VILLAWOOD

LEVEL 4 PLAN

Project no. 923 DWG #. A107

DA - ADDITIONAL INFORMATION

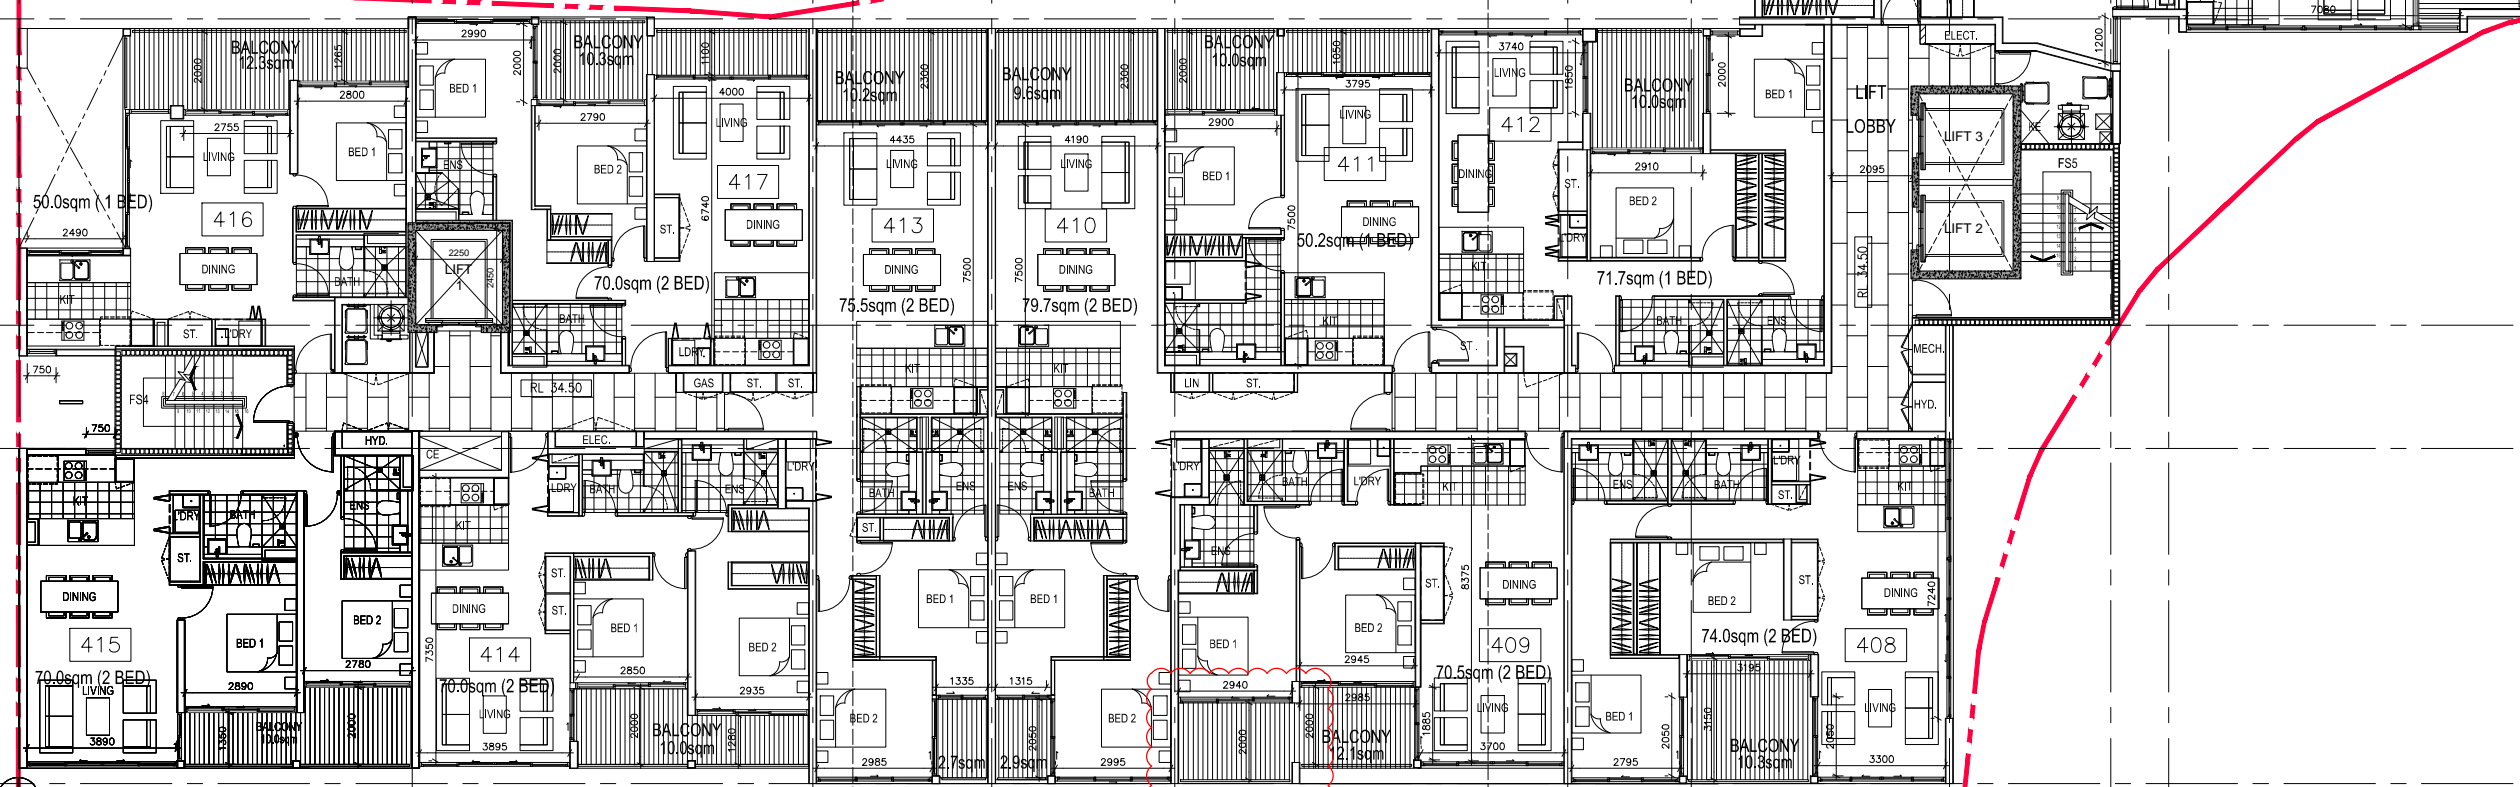
BALCONY DEPTH INCREASED TO ≥2 METERS IN DEPTH.
(AS SHOWN IN CLOUDED AREAS)
